Appl. No. 09/997,554
Amdt. dated July 29, 2004
Reply to Office Action of May 27, 2004

Amendments to the Drawings:

FIG. 2

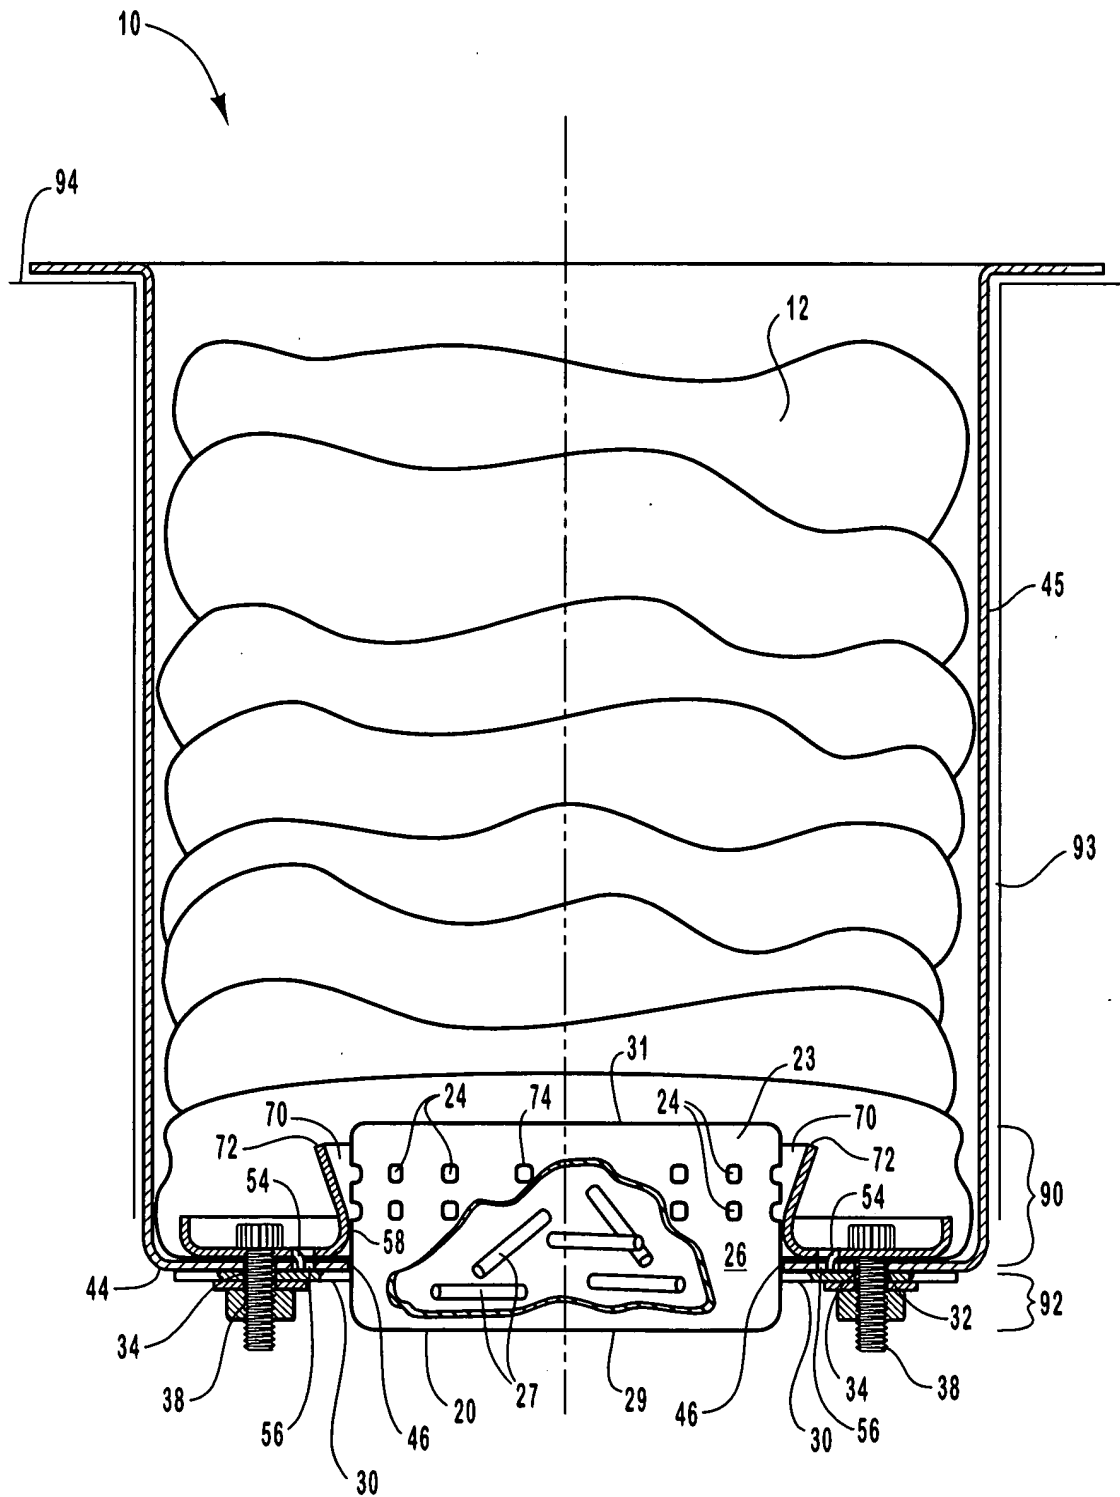
The attached sheet of drawings includes changes to Figure 2. This sheet replaces the original sheet of Figure 2. In Figure 2, the features of an instrument panel (94) has been added.
